Source: TSG_N WG "1"
Title: CRs to 3G Work Item "TEI"
Agenda item: 6.6
Document for: APPROVAL

This document contains "4" CRs on **Work Item "TEI"**, that have been agreed by **TSG_N WG "1"**, and are forwarded to **TSG_N Plenary** meeting #8 for approval.

Tdoc	Spec	CR	R ev	C A T	Rel.	Old Ver	New Ver	Subject
N1-000610	24.008	CR176	2	C	R99	3.3.1	3.4.0	Clarification of reference to Q.931 for LLC IE
N1-000626	24.008	CR191		F	R99	3.3.1	3.4.0	References and editorial corrections to 24.008
N1-000779	24.008	CR192	1	C	R99	3.3.1	3.4.0	IMEI hex coding
N1-000750	24.008	CR218	3	B	R99	3.3.1	3.4.0	Addition of "Cause of No CLI" IE in SETUP message

Figure 10.5.104/TS 24.008 Low layer compatibility information element

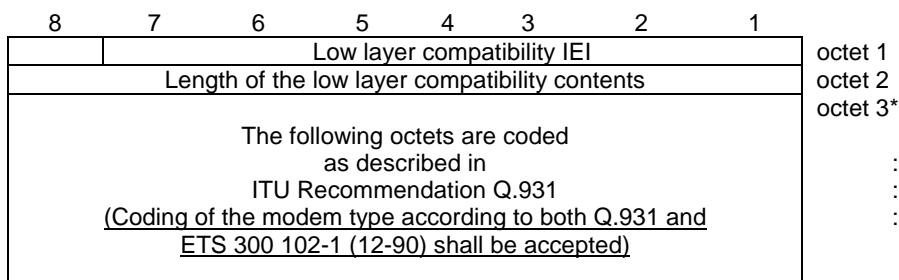
Reason for change: Due to backward compatibility problems related to the change of reference from ETS 300 102-1 to Q.931 for the LLC IE, clarifications need to be introduced.

For backward compatibility reasons coding of the modem type field according to ETS 300 102-1 (12-90) shall also be supported.

Except for the information element identifier, the low layer compatibility information element is coded as in ITU recommendation Q.931.
